**Planned Unit Development -
Lots 1 & 16 Harrison Hills—Streck, Inc.**

RECOMMENDATION REPORT

CASE NUMBER: PPUD-19-0002

RE: Planned Unit Development – Initial Review
Streck, Inc. – Harrison Hills

PLANNED UNIT DEVELOPMENT
GRADING PLAN EXHIBIT

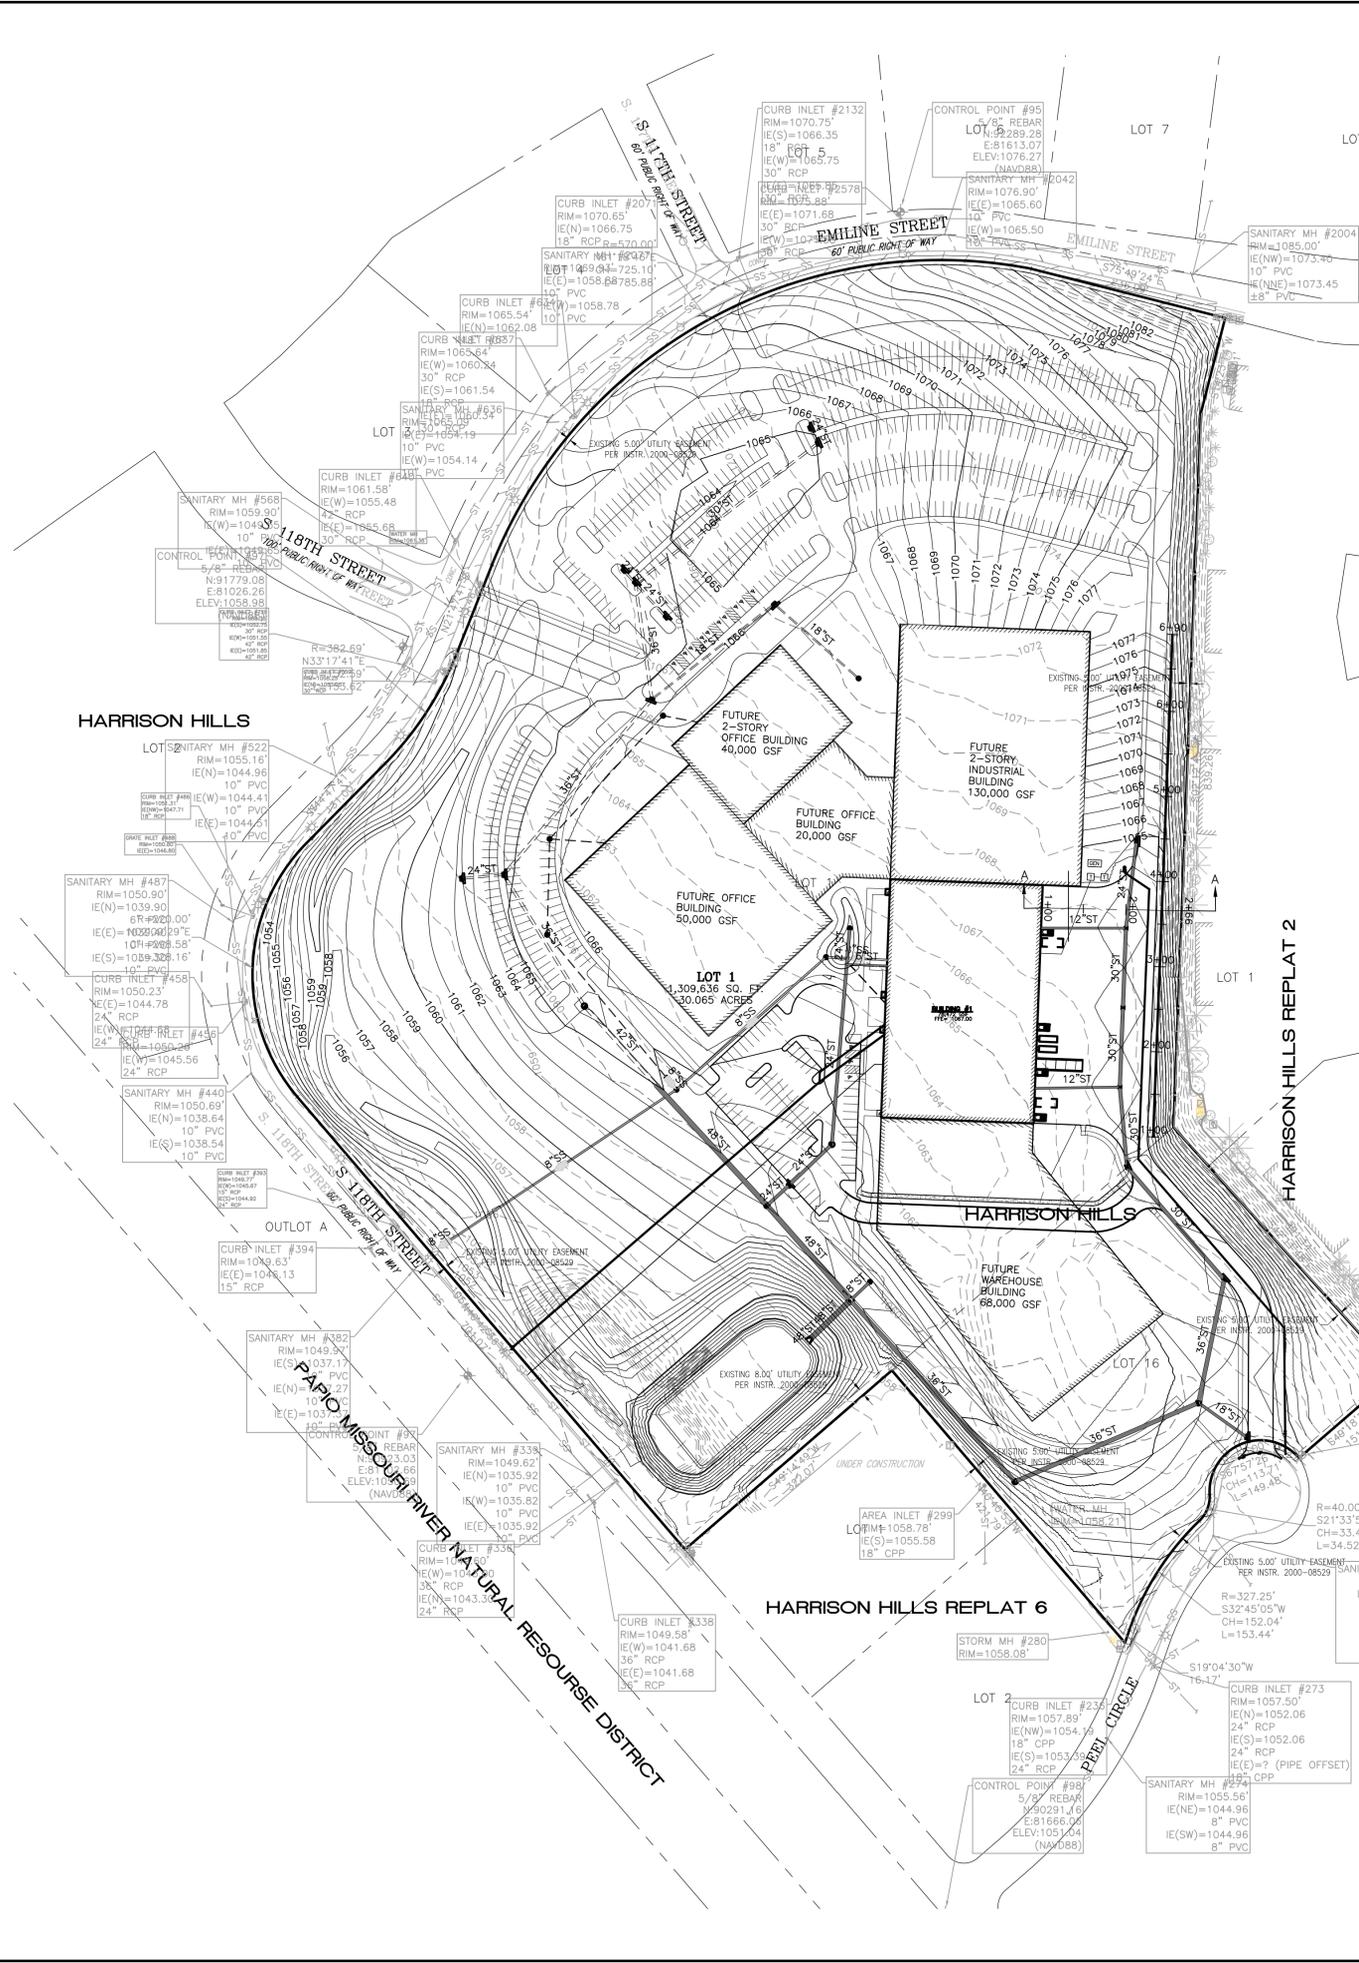
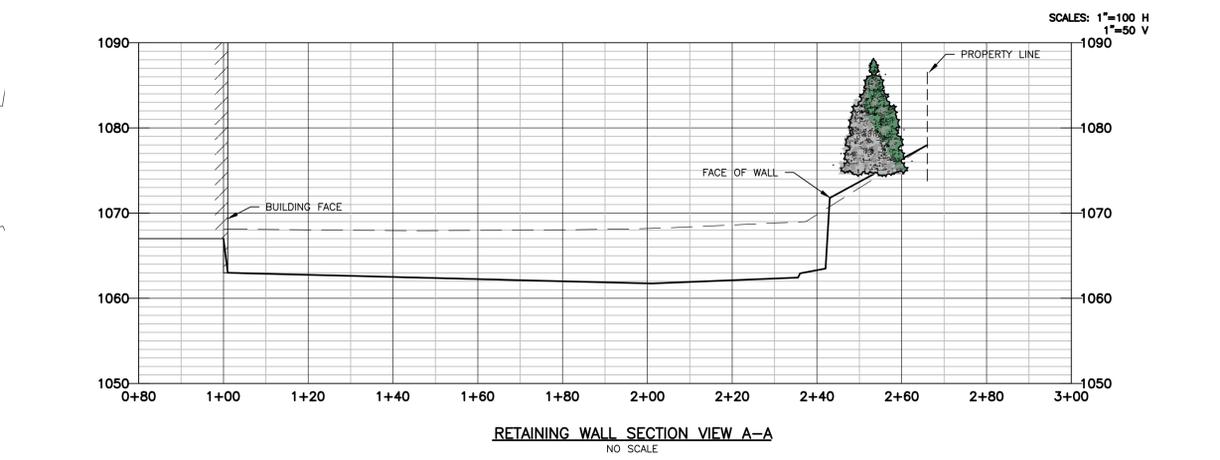
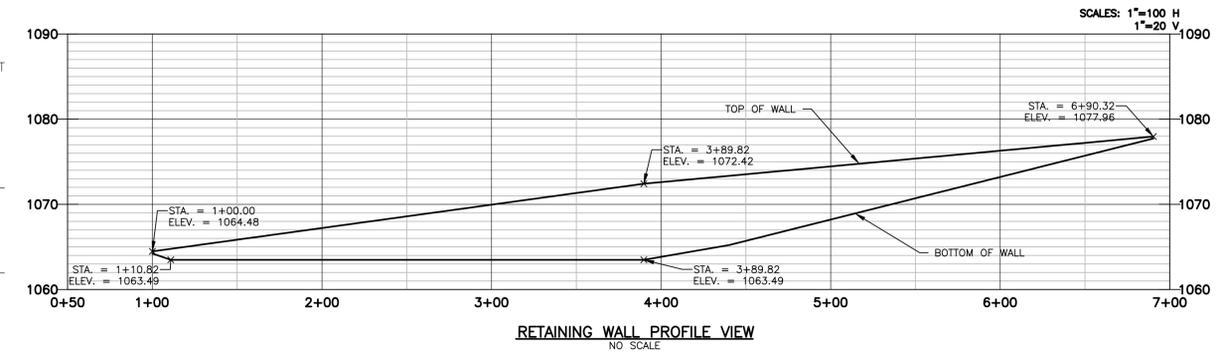
Provide an elevation and section views of the retaining wall area along the east property line. Such depictions should include proposed landscaping.

Response: A profile view and section view have been added for the retaining wall on the PUD site grading plan. Proposed retaining wall block information has also been added to the plan.

Response: A revised grading plan addressing the previous comment has been submitted for review.
